**HIGHLAND UNITED NEIGHBORS, INC., COMMENTS ON:**

*(1) DENVERIGHT COMPREHENSIVE PLAN 2040, (2) DENVERIGHT BLUEPRINT DENVER*

*November 28, 2018*

# HUNI - RECOMMENDATIONS November 28, 2018

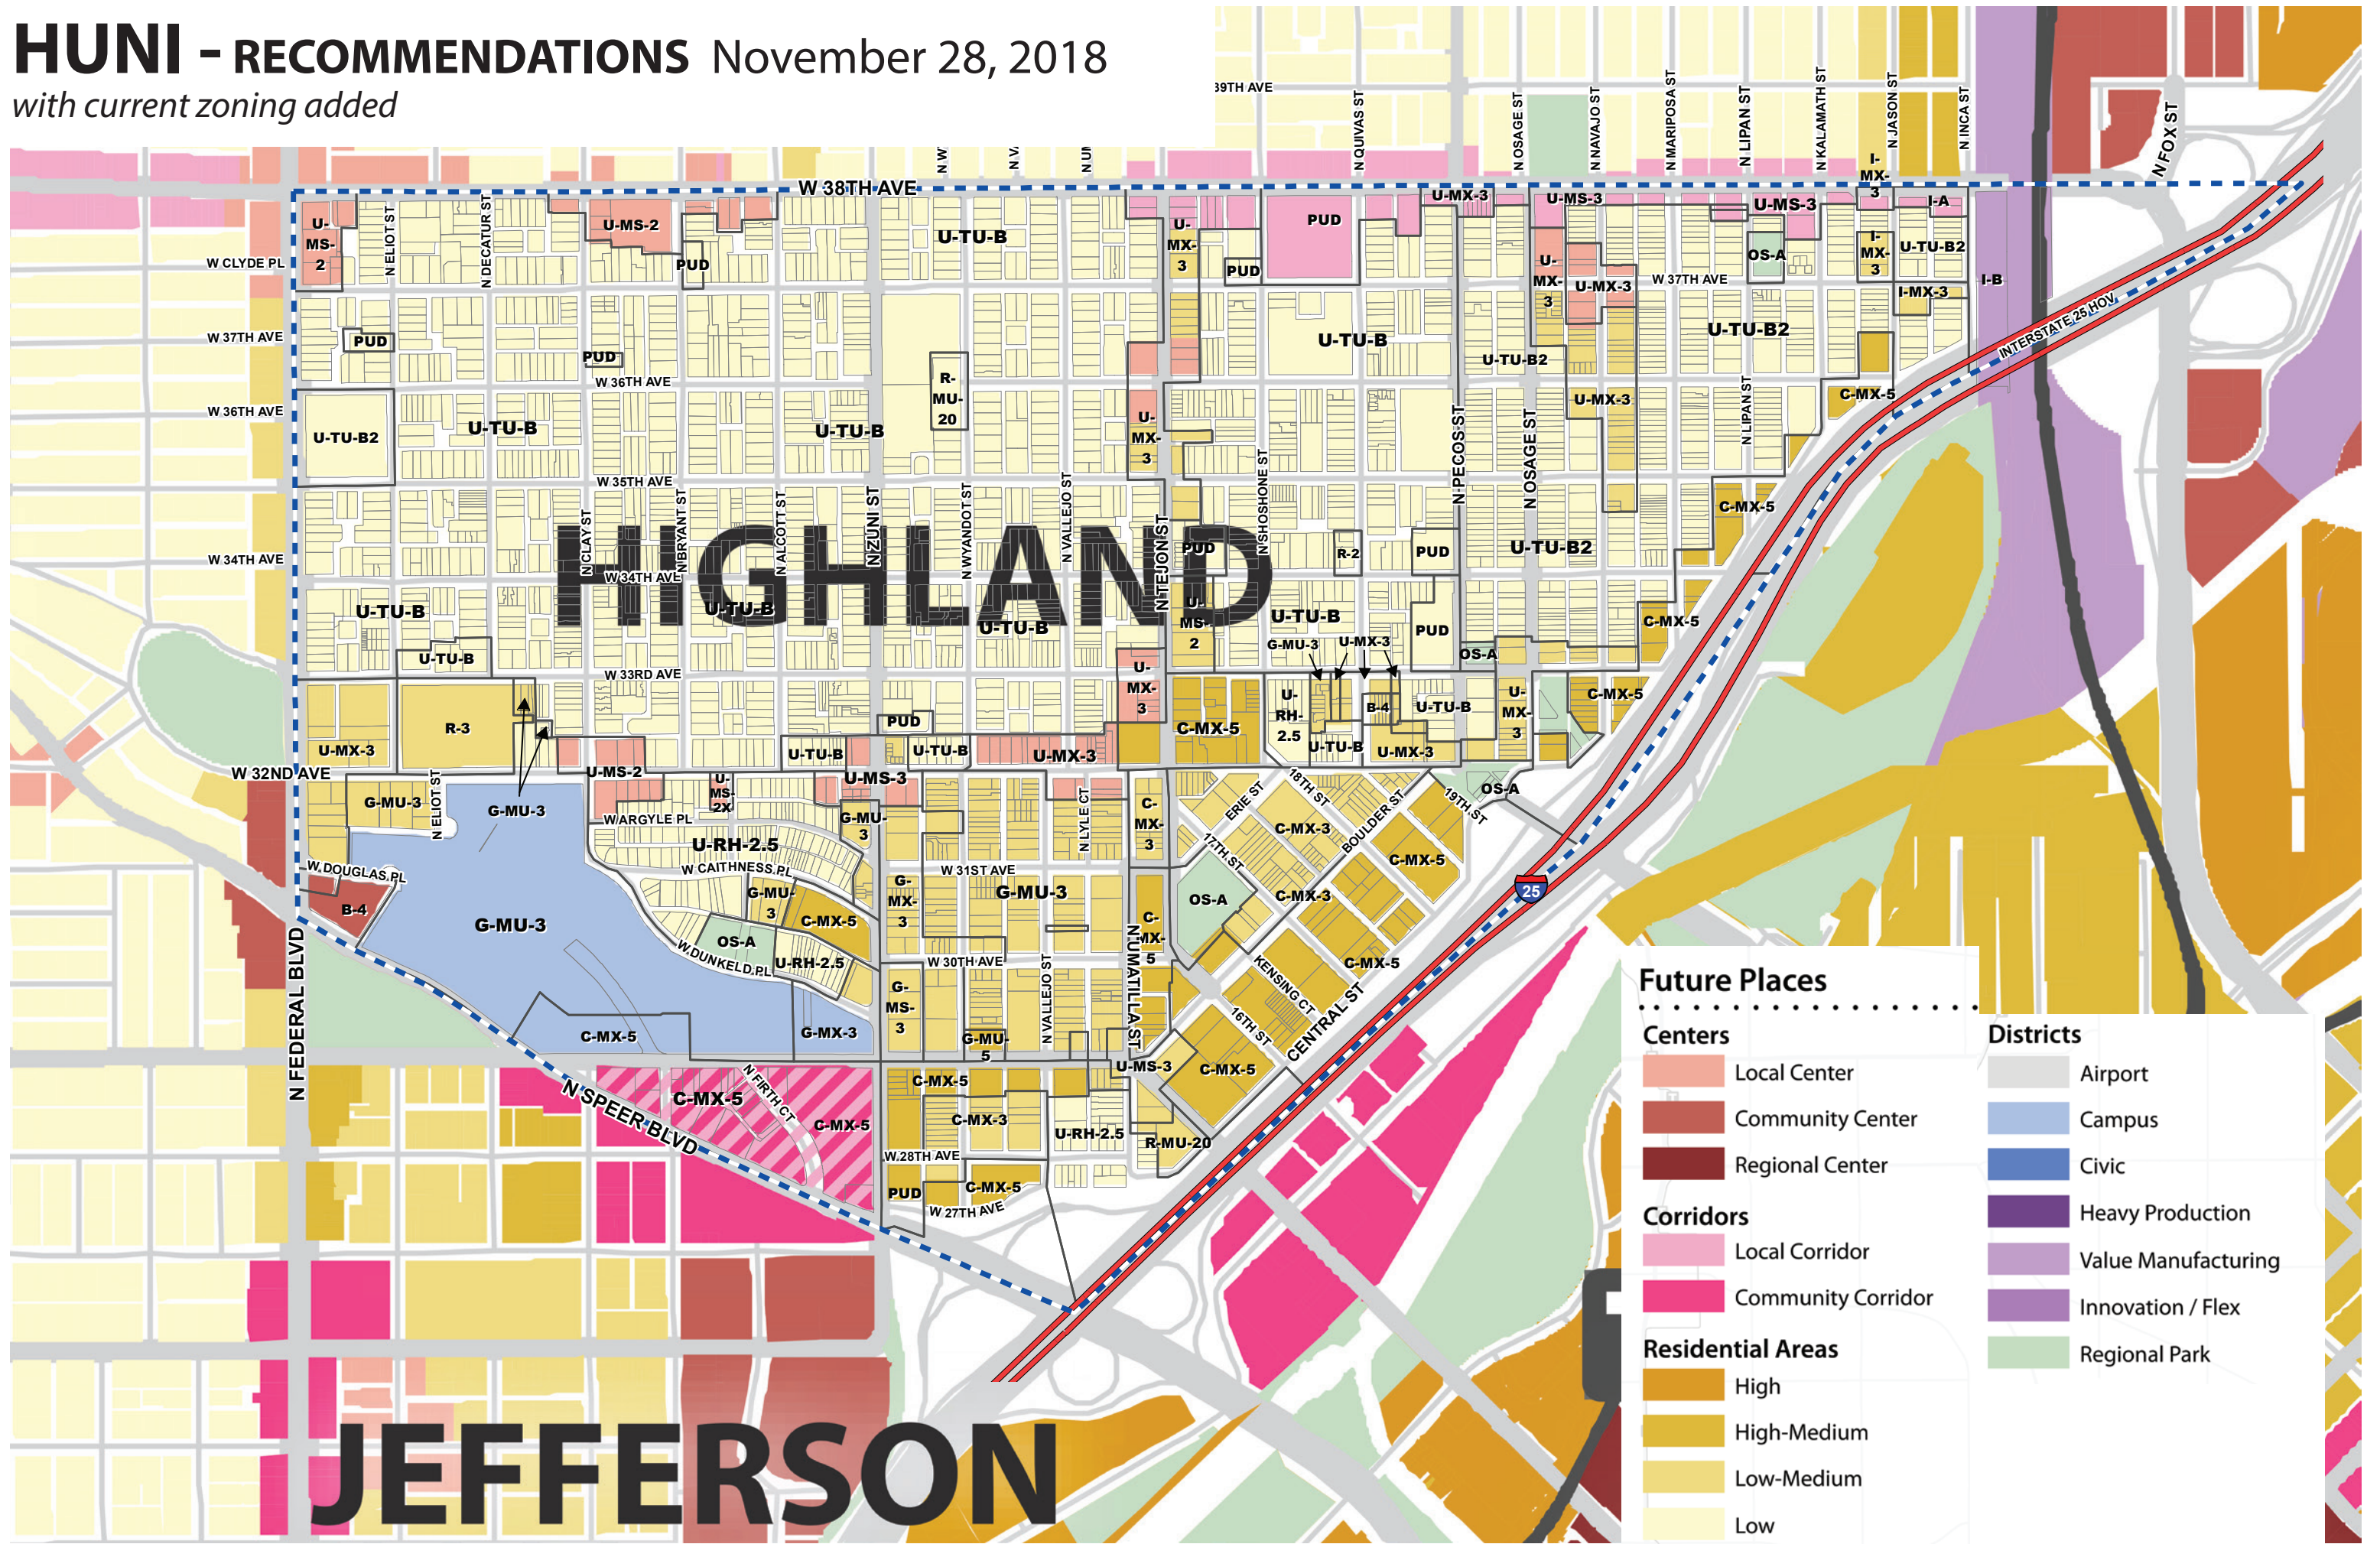
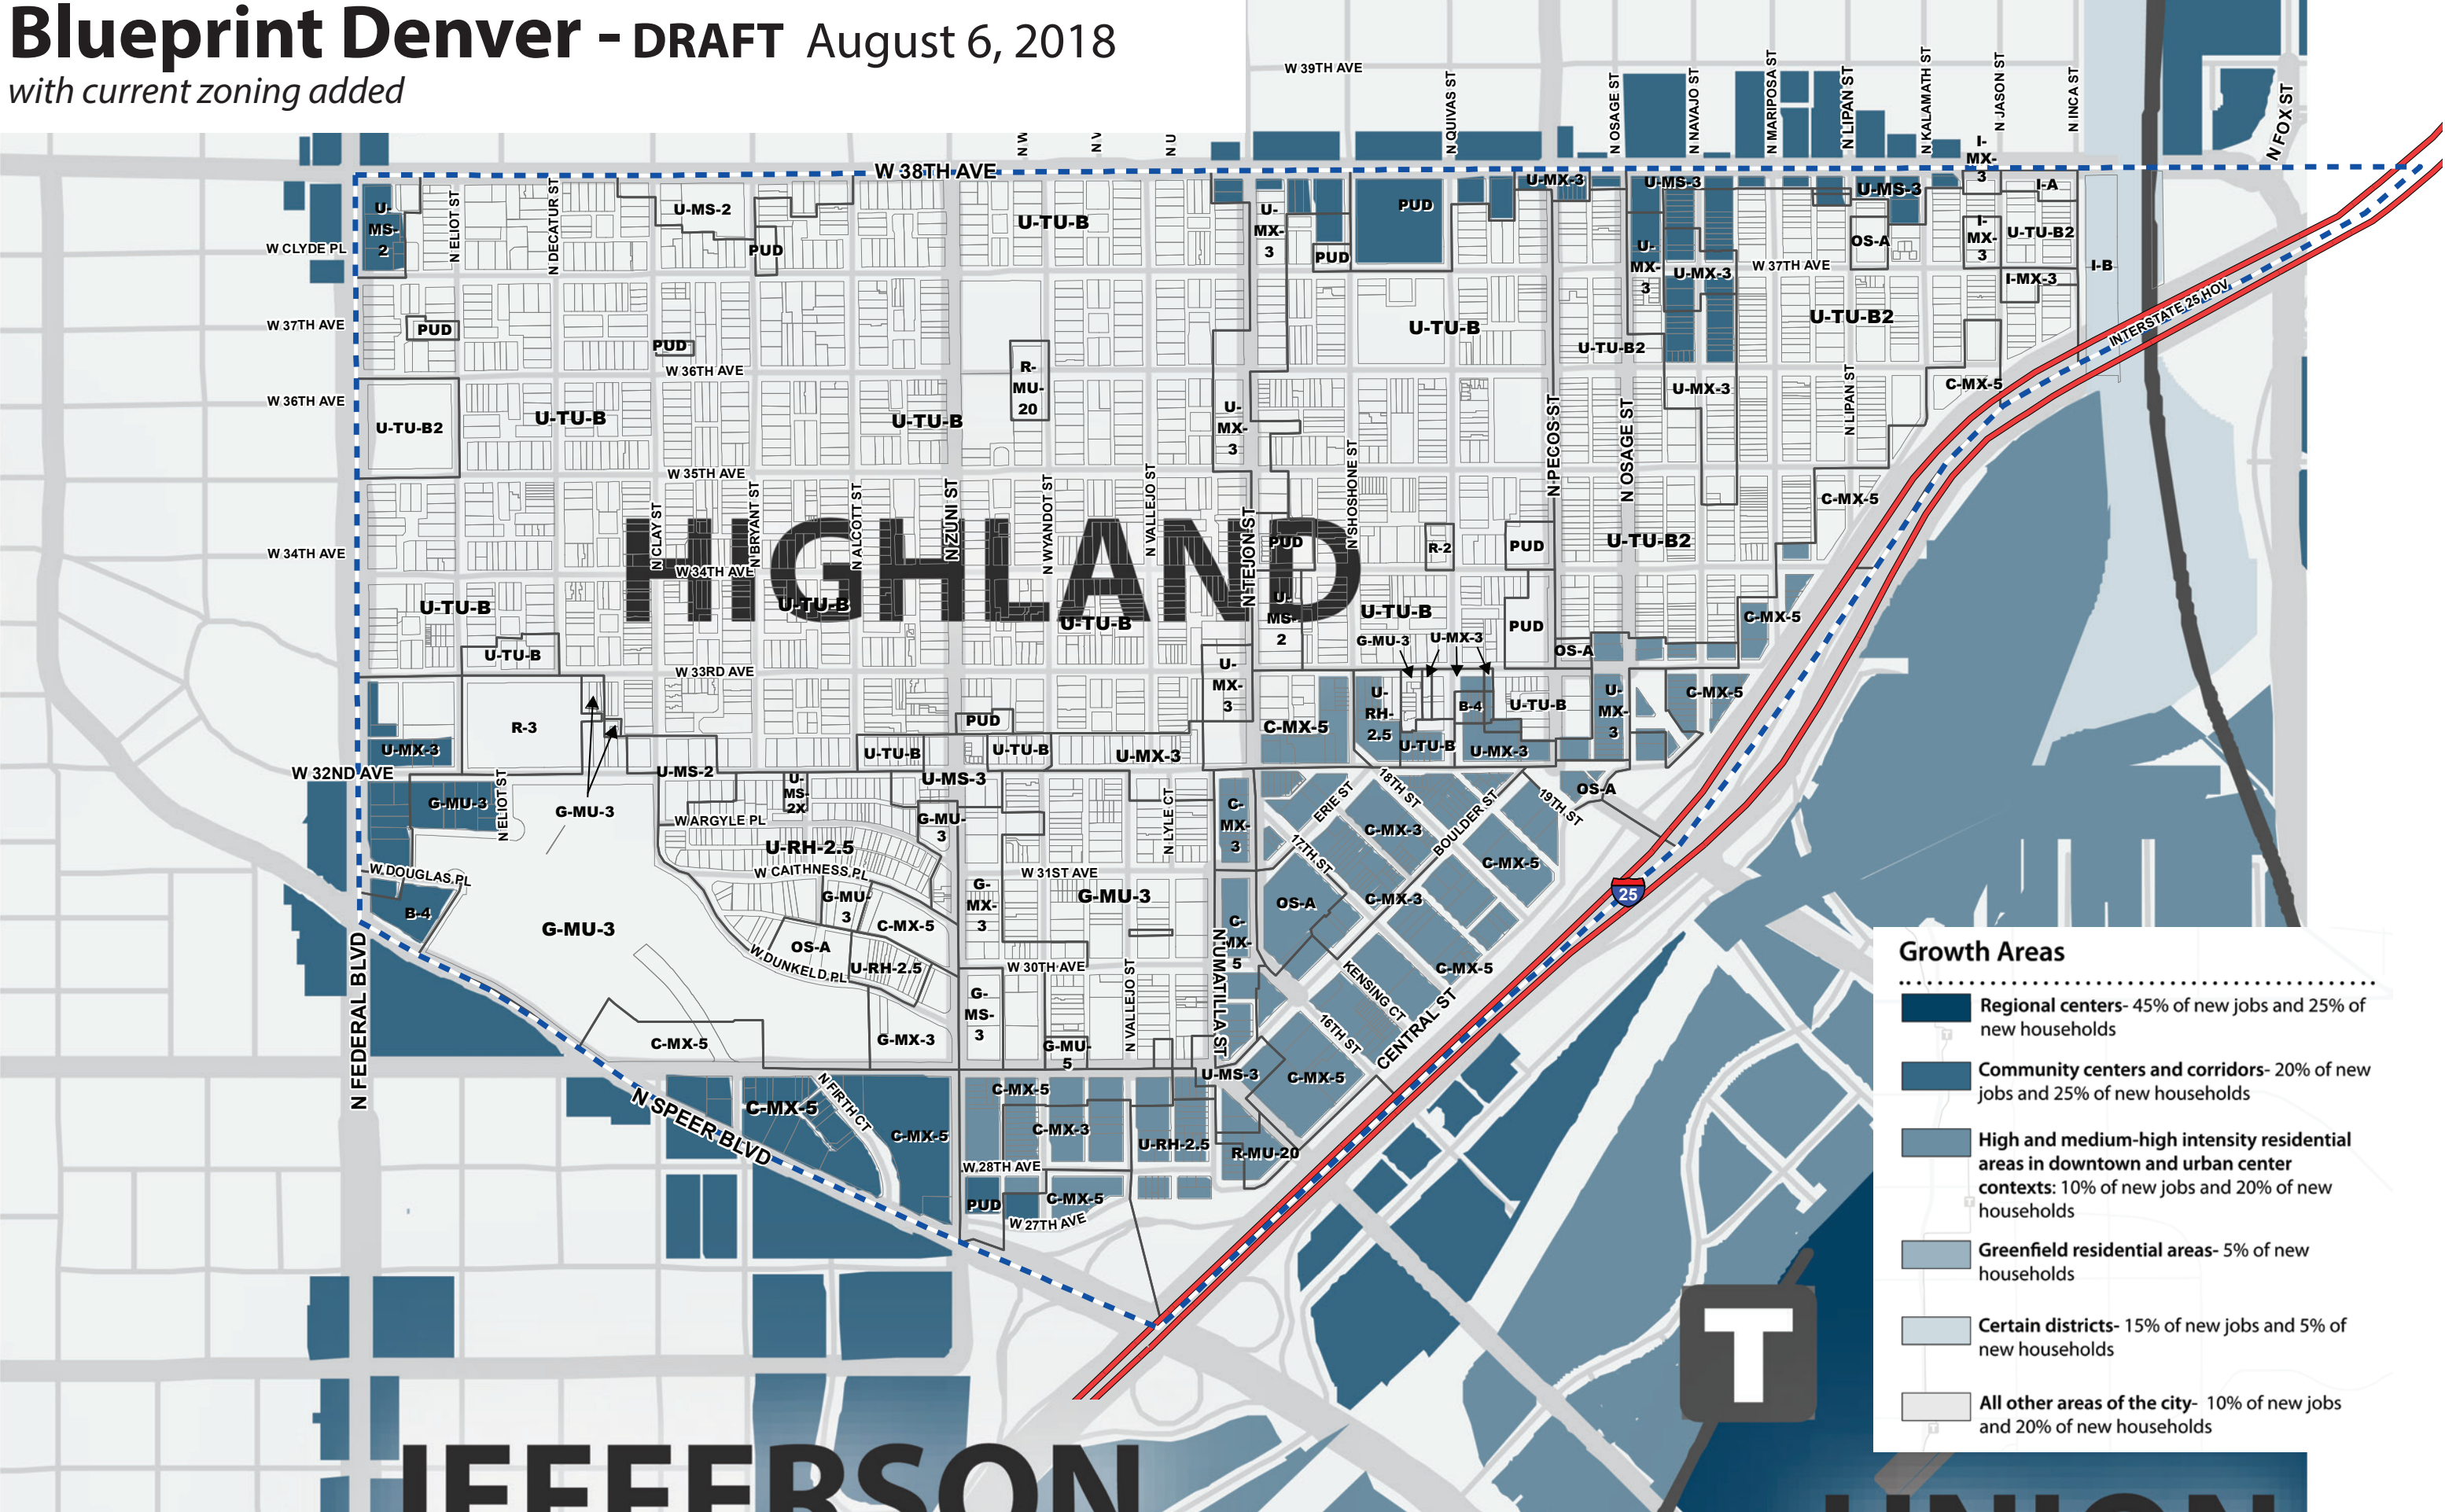
2	<b>FUTURE PLACES MAP</b>	This map mis-characterizes significant portions of the Highland Neighborhood	<i>We request that this map be updated per our version of the map. We have superimposed existing zoning districts to help clarify where the currently proposed map does not correspond to currently allowed zoning, densities, height, and locations of Centers and Corridors. SEE HUNI FUTURE PLACES MAP and specific descriptions of areas requiring modifications that follow:</i>
3	Future Places Map	Some Low Residential areas are noted as Low-Medium and High-Medium Residential Areas	Where Low Residential areas are shown as Low-Medium and Medium-High Residential Areas, the Map and accompanying descriptions of density and height would incentivize redevelopment, destroying the character of those areas of our neighborhood. Specific requests include changing the map where U-TU-B and U-TU-B2 districts along Federal Boulevard (in the Potter Highlands Landmark District) are shown as Low-Medium to Low Residential Areas, changing ALL U-RH-2.5 districts from High-Medium and Low-Medium to Low Residential Areas, and changing other U-TU-B, U-TU-B2 and U-RH-2.5 districts along West 32 <sup>nd</sup> Avenue and in Northeast Highland from High-Medium to Low Residential Areas. SEE HUNI FUTURE PLACES MAP.

4	Future Places Map	Some Low Residential areas are noted as Local Corridors	Where Low Residential areas are shown as Local Corridors, the Map and accompanying descriptions of land uses, density, and height would incentivize redevelopment, destroying the character of those areas of our neighborhood. Our specific request is to change the map where U-TU-B districts along West 32 <sup>nd</sup> Avenue and along Tejon Street are shown as Local Corridors to Low Residential Areas. SEE HUNI FUTURE PLACES MAP.
5	Future Places Map	Some C-MX-3, U-MS-3, U-MX-3, B-4, and G-MU-3 districts are mis-characterized as High-Medium Residential Areas	Where C-MX-3, U-MS-3, U-MX-3, B-4, and G-MU-3 districts are shown as High-Medium Residential Areas, the Map and accompanying descriptions of land uses, density, and height would incentivize redevelopment beyond current zoning regulations, destroying the character of those areas of our neighborhood. These 3-story districts should be shown as Low-Medium Residential Areas. Our specific requests include changing the map where C-MX-3 and U-MS-3 districts south of West 32 <sup>nd</sup> Avenue and east of Zuni Street are shown as High-Medium Residential to Low-Medium Residential Areas, where U-MX-3, G-MU-3, and B-4 districts along West 32 <sup>nd</sup> Avenue, West 33 <sup>rd</sup> Avenue (East of Shoshone) and Pecos Street are shown as High-Medium Residential to Low-Medium Residential Areas, and where a G-MU-3 district at West Caithness Place and Fife Court is shown as High-Medium Residential to a Low-Medium Residential Area. SEE HUNI FUTURE PLACES MAP.

6	Future Places Map	Some U-MX-3 and G-MU-3 districts are mis-characterized as Community Corridors	Where U-MX-3 and G-MU-3 districts are shown as a Community Corridor, the Map and accompanying descriptions of land uses, density, and height would incentivize redevelopment beyond current zoning regulations, significantly altering the character of those areas of our neighborhood. These 3-story districts should be shown as Low-Medium Residential Areas. Our specific request it to change the map

where U-MX-3 and G-MU-3 districts at West 32 <sup>nd</sup> Avenue and Federal Boulevard are shown as a Community Corridor to Low-Medium Residential Areas. SEE HUNI FUTURE PLACES MAP.
7	Future Places Map	The U-MS-3 parcel at the NE corner of West 32 <sup>nd</sup> Avenue and Zuni Street is mis-characterized as a Local Center.	The U-MS-3 parcel at the NE corner of West 32 <sup>nd</sup> Avenue and Zuni Street is mis-characterized as a Local Center. This is a residential structure developed by a neighborhood organization. Our request is to change the mapping from Local Center to Low-Medium Residential Area. SEE HUNI FUTURE PLACES MAP.
8	Future Places Map	The B-4 parcel at the NE corner of Speer and Federal is mis-characterized as a Community Corridor.	The B-4 parcel at the NE corner of Speer Boulevard and Federal Boulevard is mis-characterized as a Community Corridor. Because commercial uses along both Boulevards in Highland tend to be nodal rather linear, we request that this parcel be changed from Community Corridor to Community Center. SEE HUNI FUTURE PLACES MAP.

9	Future Places Map	The C-MX-5 triangle bounded by West 29 <sup>th</sup> Avenue, North Speer Boulevard, and Zuni Street does not fit within the descriptions allowed in a Community Corridor in the Urban Context.	The C-MX-5 triangle bounded by West 29 <sup>th</sup> Avenue, North Speer Boulevard, and Zuni Street should allow 5-story redevelopment (currently allowed for this zoning). Local Corridor designation recommends development up to 3 stories. Community Corridor designation recommends development between 5 and 12 stories in the Urban Context. There is a missing option for areas where 3 to 5 stories is appropriate. Our request is to develop middle option for Corridors where 3-5 stories are recommended. SEE HUNI FUTURE PLACES MAP.
10	Future Places Map	Some U-MS-2 districts are mis-characterized as Community Centers or Local Corridors.	Along West 38 <sup>th</sup> Avenue between Federal Boulevard and Alcott Street, areas zoned U-MS-2 are mapped as Community Center (3-5 stories) or Local Corridor (3 stories). This is another location where the commercial uses are at nodes rather than being continuous along a corridor. These designations on the Map and in accompanying descriptions of land uses, density, and height would incentivize redevelopment beyond current zoning regulations, significantly altering the character of those areas of our neighborhood which are particularly sensitive to change because of the adjoining Potter Highlands Landmark District. Heights are currently limited to two stories. Our request is to change the Map from Community Center and Local Corridor to Local Center to better align with the Highland Neighborhood. SEE HUNI FUTURE PLACES MAP.

11	Future Places Map	Some U-MX-3 and U-MS-2 areas are mis-characterized as Local Corridors, Community Corridors, and Low Residential Areas.	U-MX-3 and U-MS-2 districts along Tejon Street, Osage Street, Pecos Street, and West 38 <sup>th</sup> Avenue are mapped primarily as Local and Community Corridors (5-8 stories). For accuracy, we believe that several changes are needed to more accurately represent the type of development that should occur along these streets: Along Tejon, areas that are primarily residential should be mapped as Low-Medium Residential Areas, and areas that are mixed-use or commercial should be mapped as Local Centers. Along West 38 <sup>th</sup> Avenue, the areas mapped as Community Corridors should be changed to Local Corridors to align with heights

that are allowed by current zoning. The same changes should be made to mixed-use and commercial areas along Osage and Pecos Streets. Where U-MX-3 zoned areas have residential structures, the Future Places Map should be changed to show Low-Medium Residential Areas. SEE HUNI FUTURE PLACES MAP.
12	Future Places Map	Some I-MX-3 and I-A areas are mis-characterized as Low-Medium and High-Medium Residential Areas.	Along West 38 <sup>th</sup> Avenue, east of Kalamath, the I-MX-3 and I-A areas are mis-characterized as Low-Medium and High-Medium Residential Areas. We request that these areas be changed to Local Corridor for consistency with the rest of the 38 <sup>th</sup> Avenue corridor east of Tejon. SEE HUNI FUTURE PLACES MAP.
13	Future Places Map	The C-MX-5 district on the north side of the intersection of West 32 <sup>nd</sup> Avenue and Tejon Street is characterized as a combination of Local Corridor and Medium-High Residential while being primarily Medium-High Residential.	The C-MX-5 district on the north side of the intersection of West 32 <sup>nd</sup> Avenue and Tejon Street is characterized as a combination of Local Corridor and Medium-High Residential while being primarily Medium-High Residential. We request that the entire C-MX-5 zone district at this location be shown as a Medium-High Residential Area to conform to actual and proposed development. SEE HUNI FUTURE PLACES MAP.
